SERVICE BULLETIN

DATE: 20 March 1953  
MODEL: 300  
BULLETIN NO: 12  
PAGE NO: 1

### CYCLOHM DRIVE MOTORS

### DRIVE MOTOR REPLACEMENT

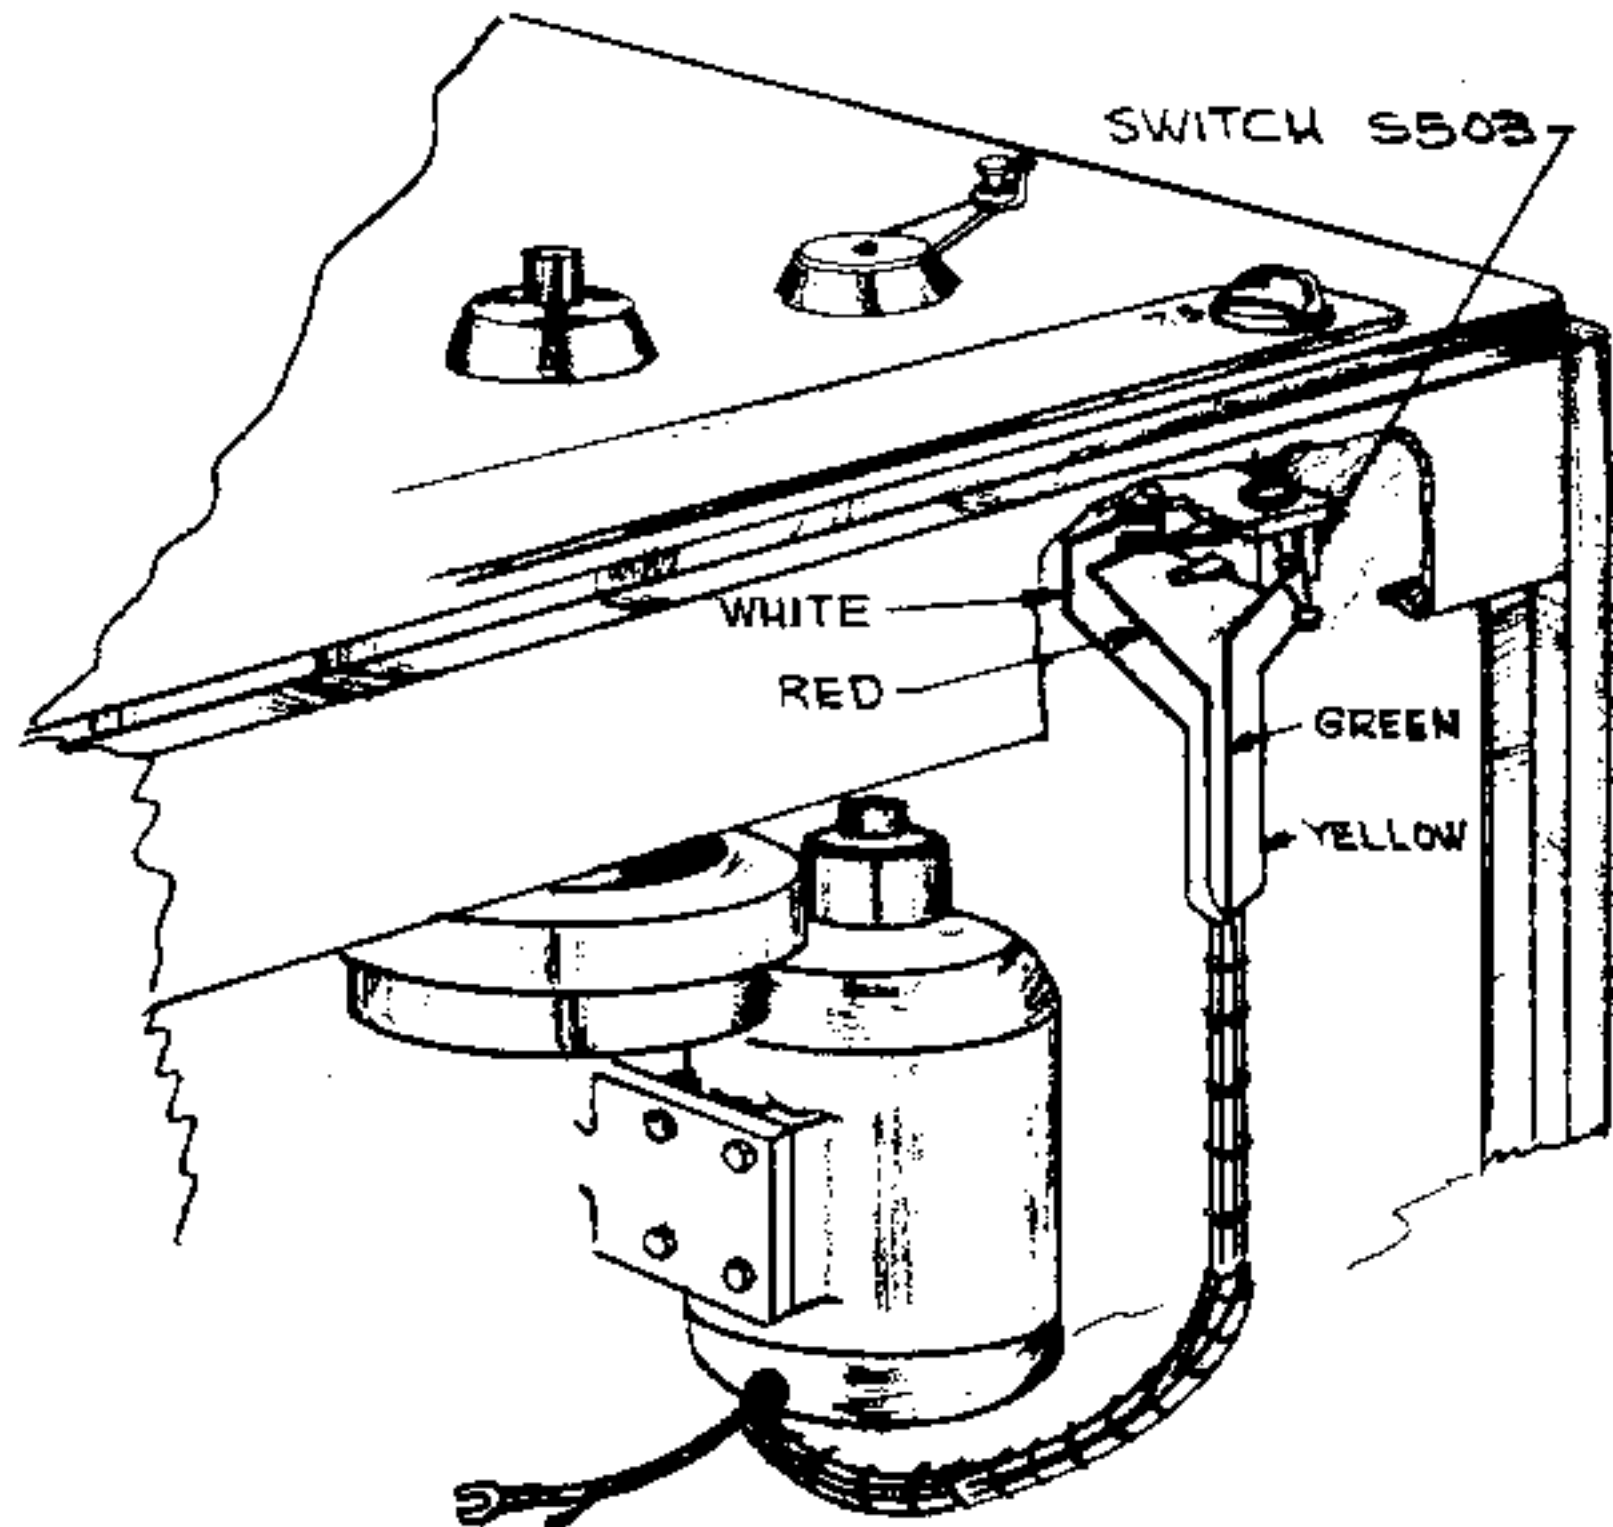
1. Capstan Motor. Failure of the capstan drive motor has been reported by several users of the Model 300 recorder. These failures have been described as a knocking noise which develops in the motor, sometimes accompanied by loss of torque.

Investigation of motors which have been returned to our factory have revealed a defect in the mechanical design. These motors have therefore been returned to the manufacturer who has redesigned the units to overcome these defects in all respects. All motors which have exhibited this mechanical failure in the field are being replaced with the redesigned motor.

To install the new motor, first remove the old unit by unsoldering the leads from the switch S-502 and removing the black lead from Terminal Strip. Remove the four mounting screws which fasten the motor to the hinged bracket.

Install the new motor and connect as shown in the accompanying illustration, being careful to follow the color code of the leads. Before tightening the four screws in the motor base, swing the motor pulley into contact with the rubber tire and check for alignment. (Motor and Capstan shafts should be approximately parallel) A slight amount of adjustment is available due to the clearance of the holes in the hinged bracket supporting the motor.

BLACK WIRE TO NO. 1  
TERMINAL ON DRIVE  
ASSEM. TERMINAL  
STRIP TS 501
